## TEMPORARY EROSION CONTROL DETAILS

**STANDARD**

**T-1**

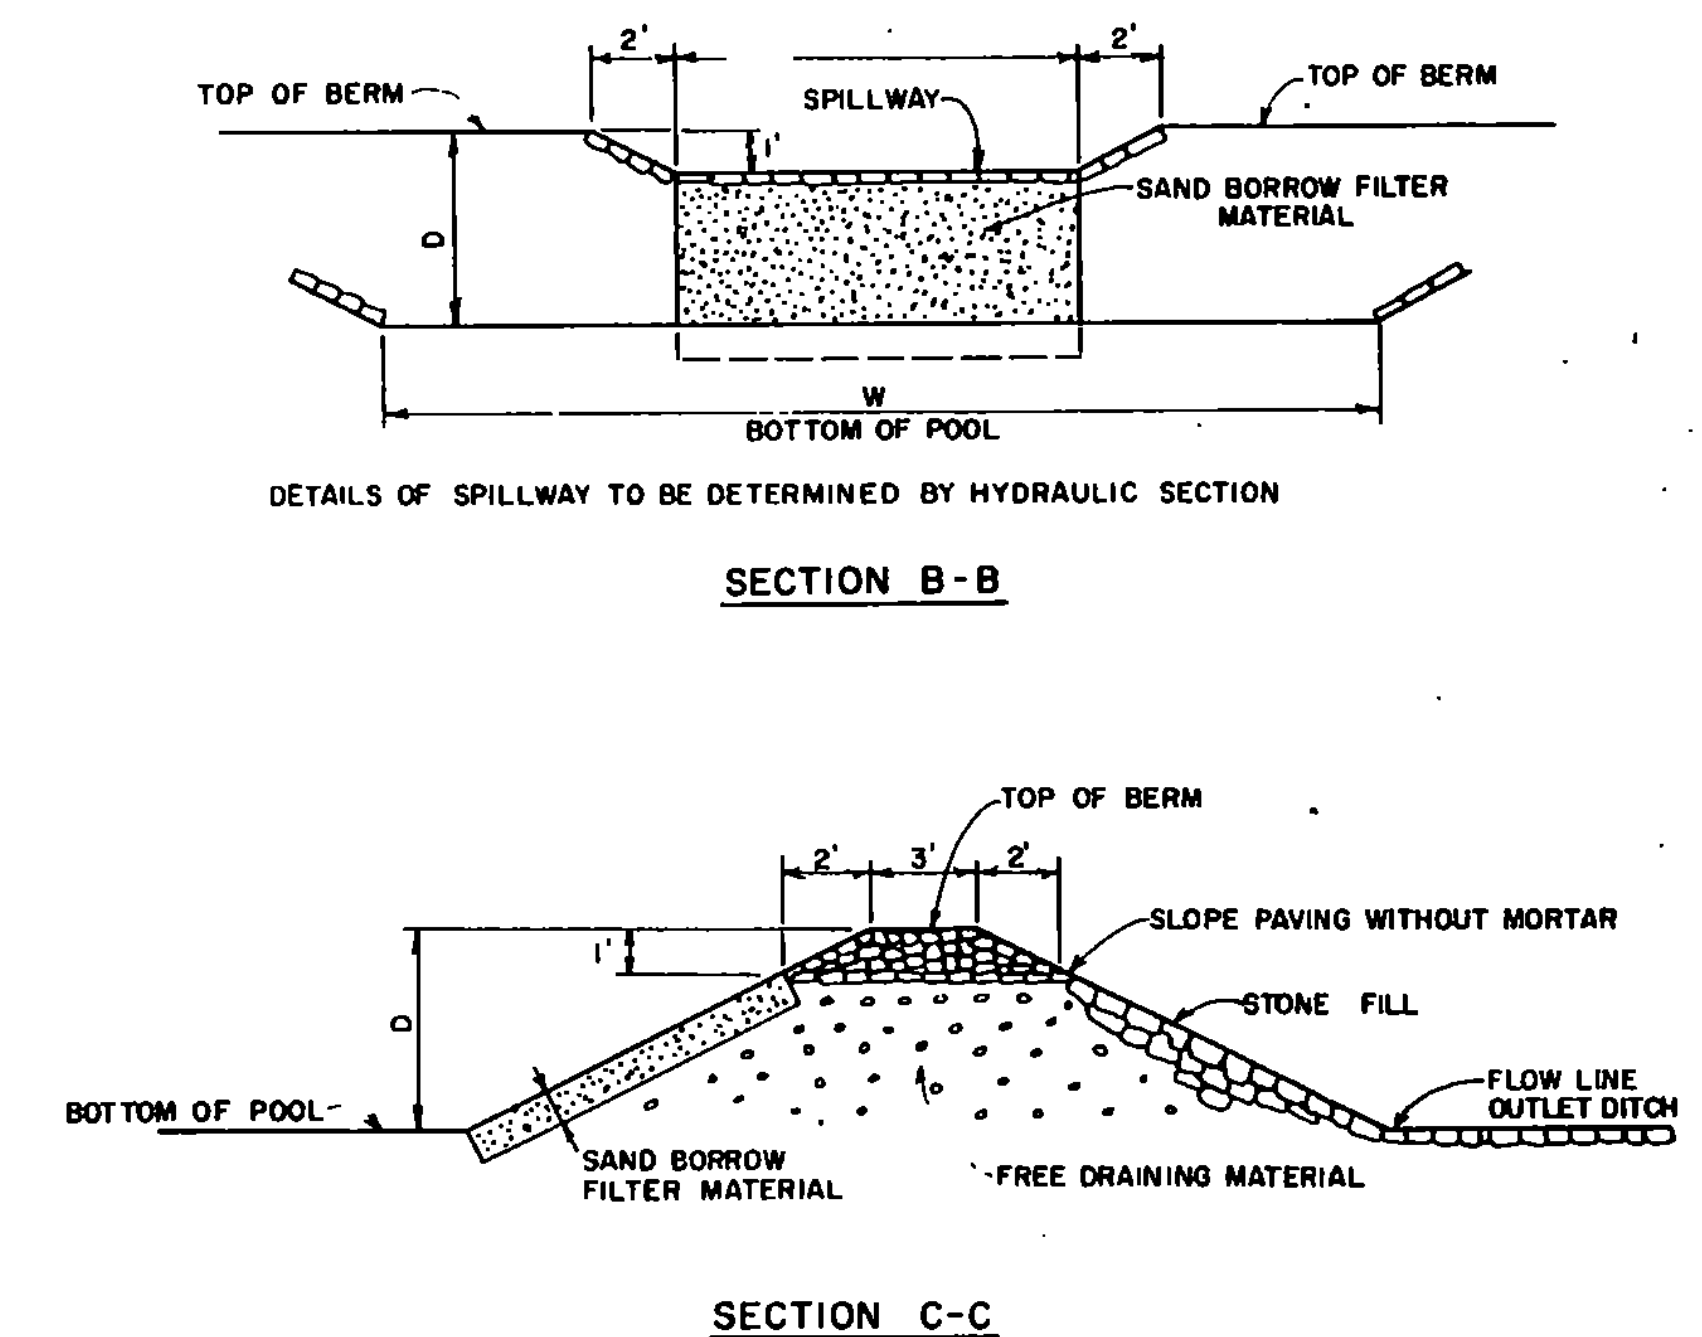
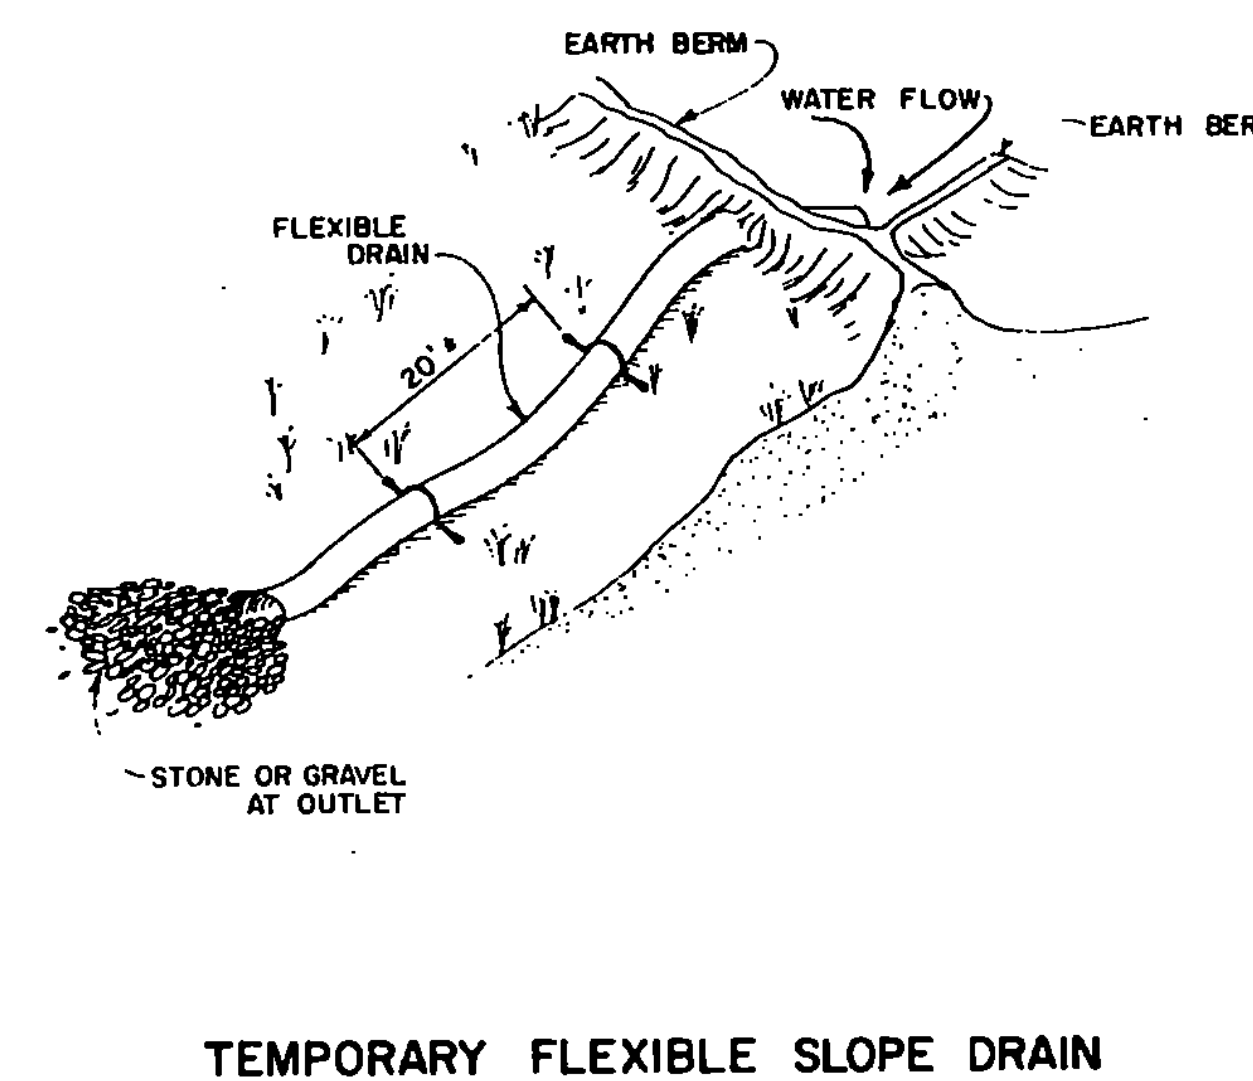
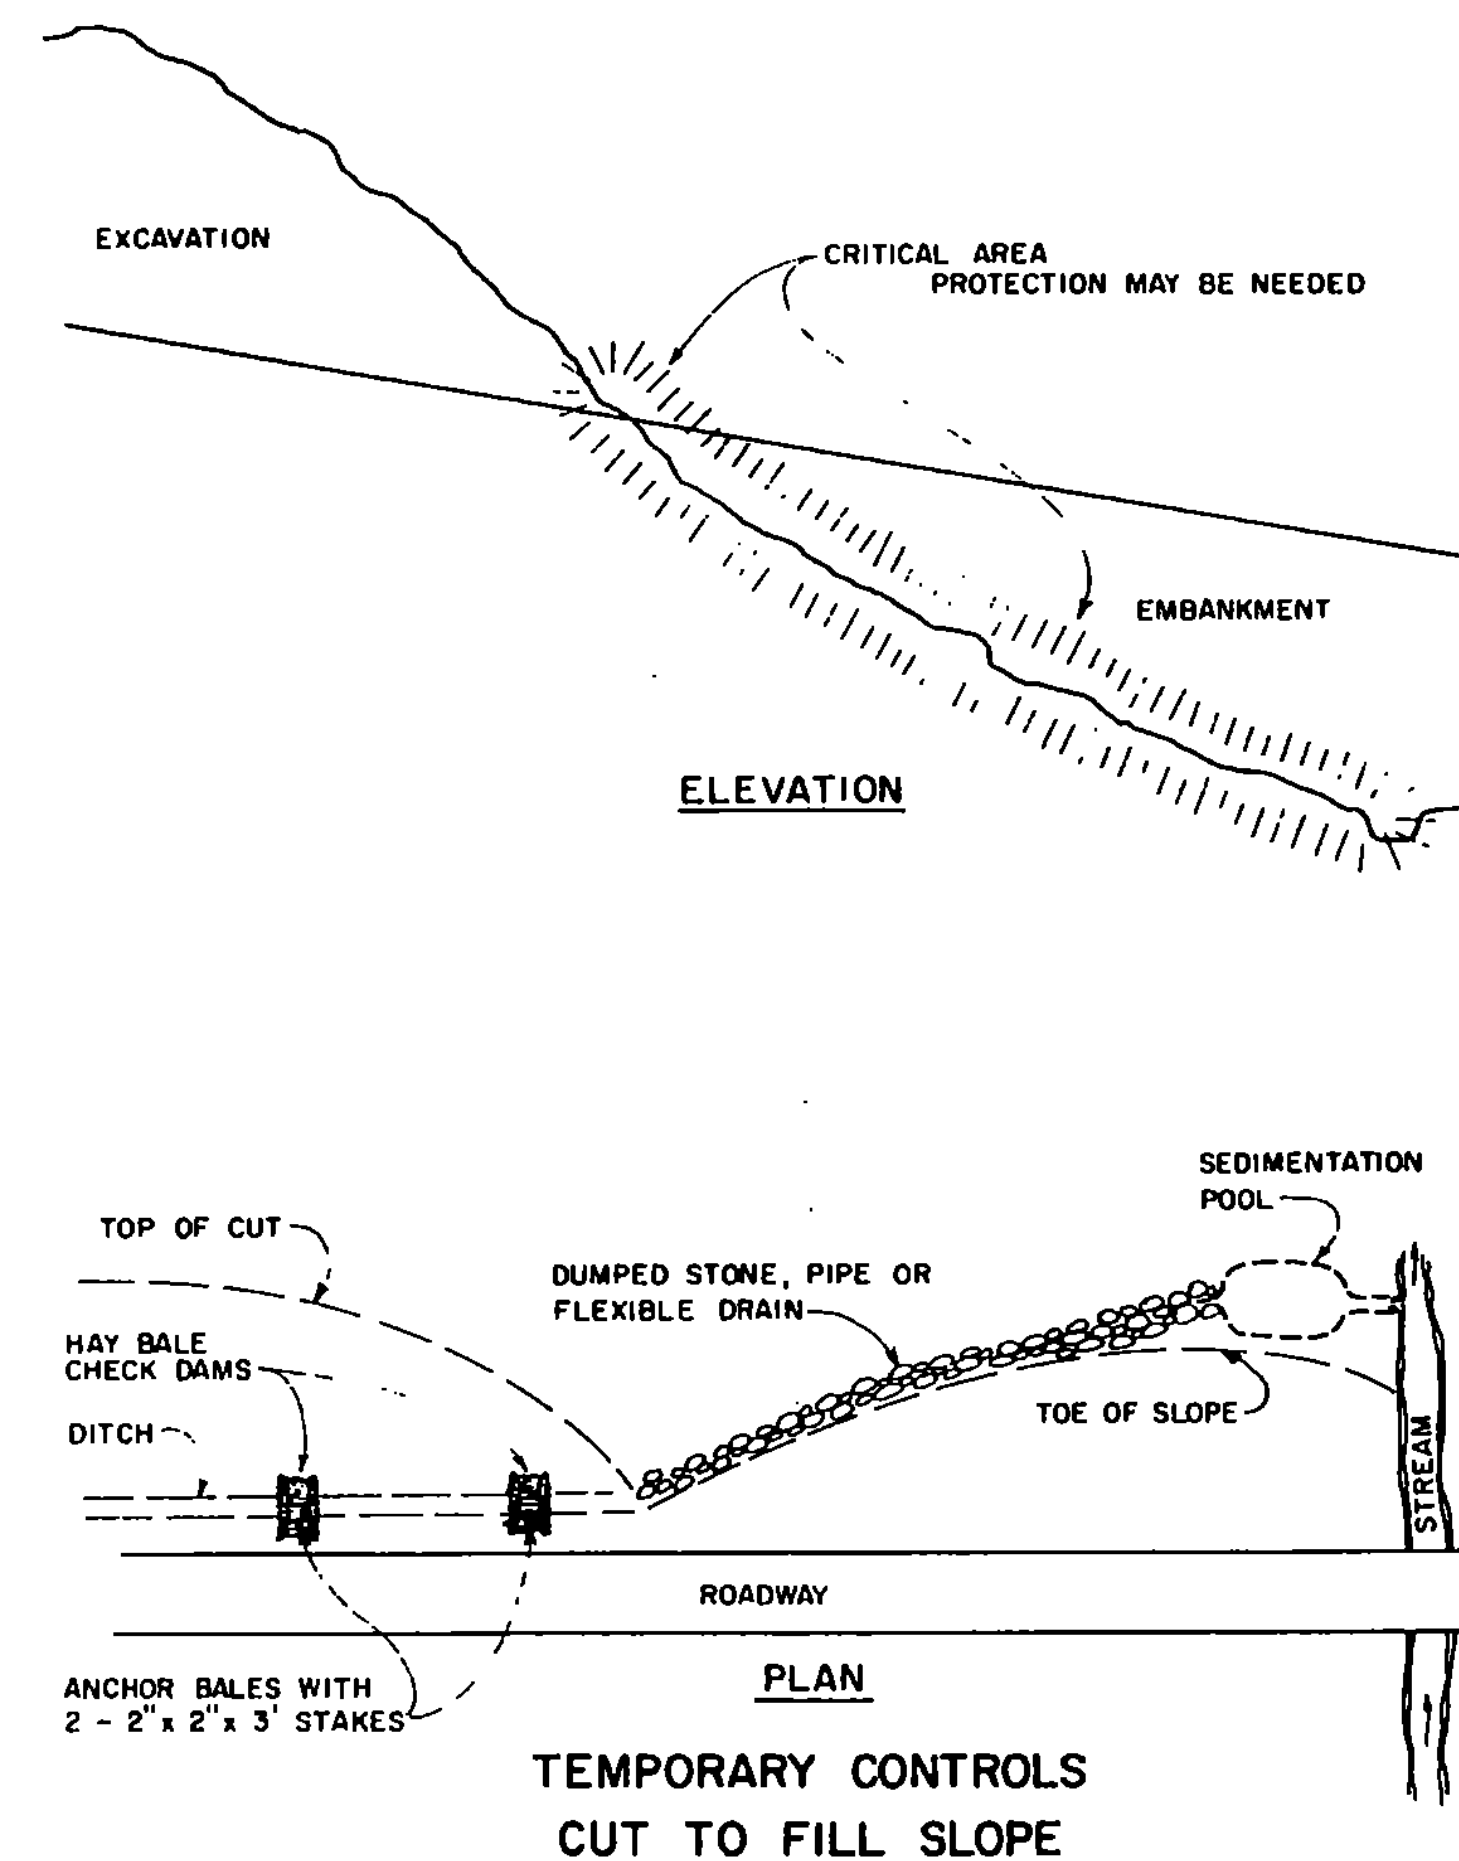
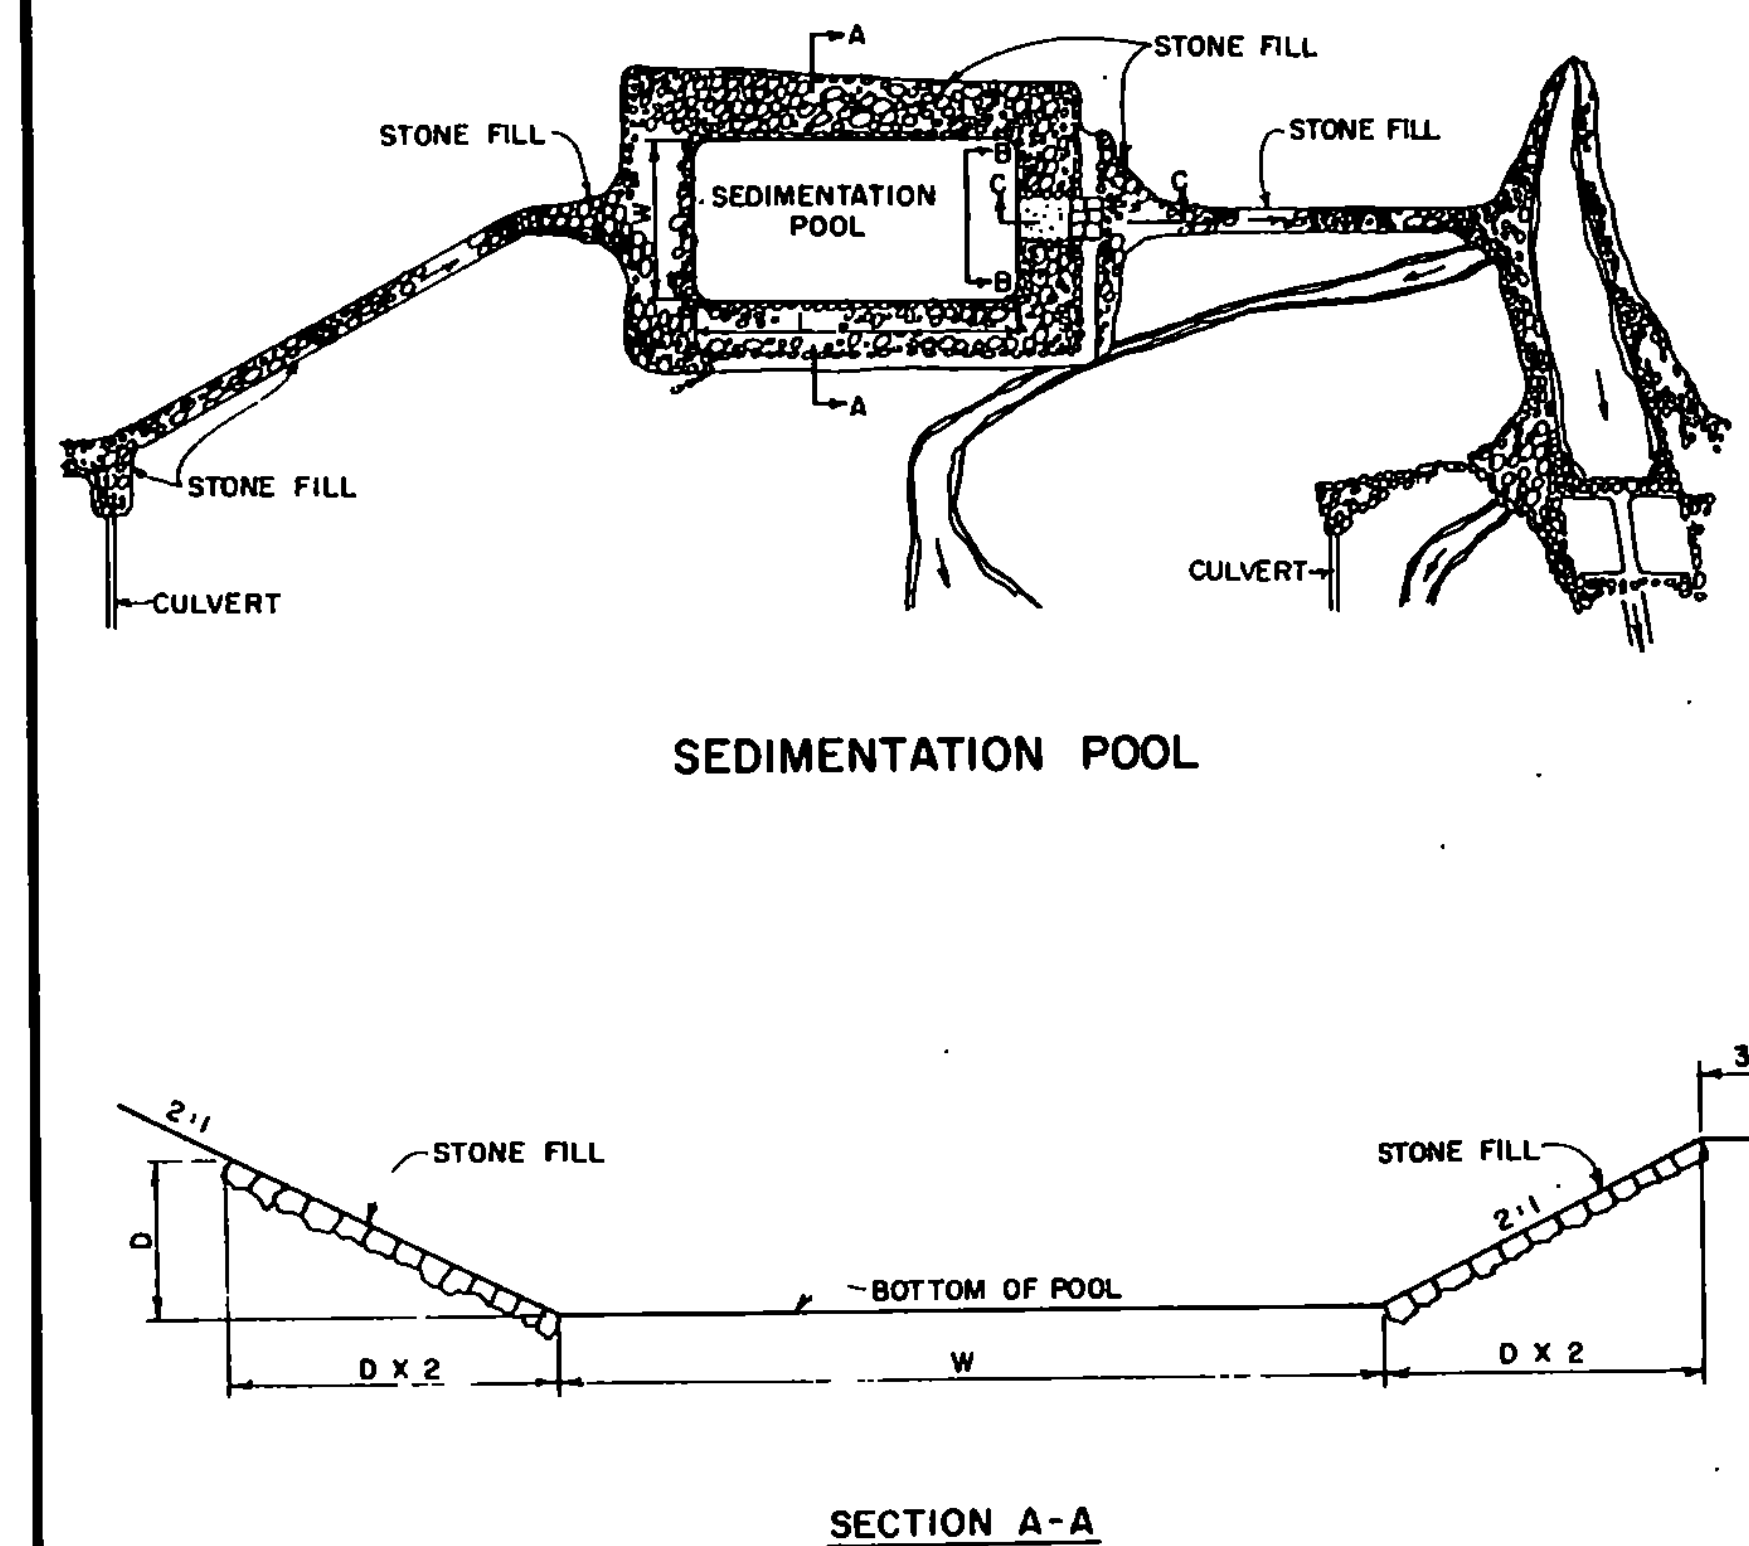
JUNE 14, 1973 - SEDIMENT TRAPS REMOVED FROM TEMPORARY  
BERMS AND SLOPE DRAINS FOR FILL SLOPES.

FEB. 26, 1976 - SILT FENCE ADDED.

DEC. 7, 1976 - HAY BALE ANCHOR NOTE ADDED.
